CERTIFICATE OF APPROPRIATENESS

Property: 821 Highland St, Lot 9, Block 42, Woodland Heights Subdivision. The property includes a historic 1,829 square foot, two-story wood frame single-family residence and a detached garage situated on a 5,000 square foot (50' x 100') interior lot.

Proposal: Alteration – Windows

NORTH (REAR) ELEVATION

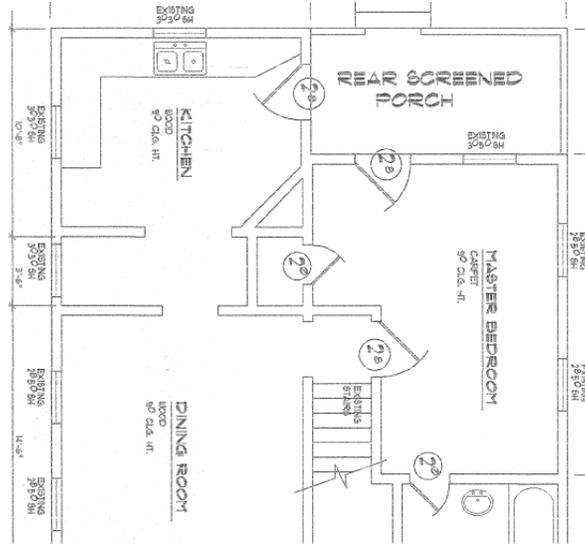
Rear Elevation: The rear elevation is not visible from the public right of way, but is included here for reference to
(North) overall scope.

FIRST FLOOR PLAN

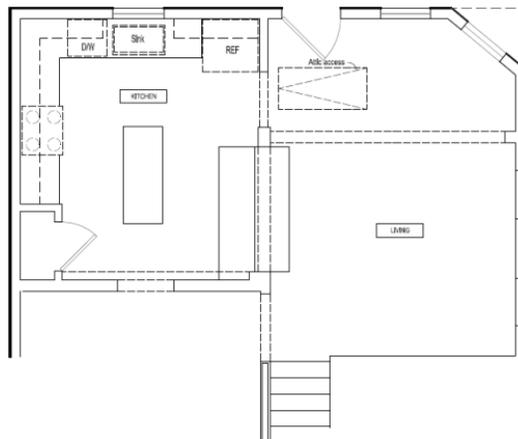
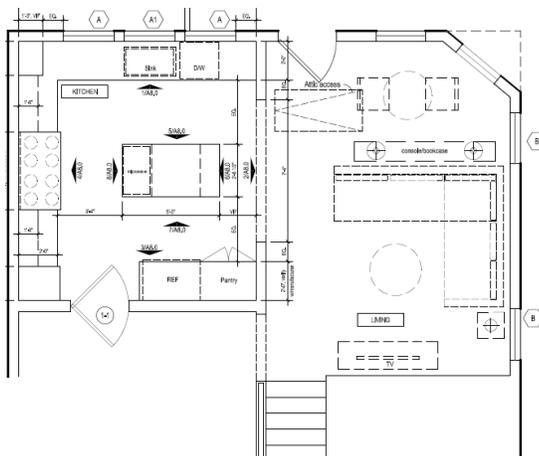
Windows/Doors: The applicant proposes to remove two fixed non-original vinyl windows on the east elevation and install two new 1/1 single-hung vinyl windows in new openings to match existing non-original windows in style and dimension. The windows will measure approximately 32" x 60".
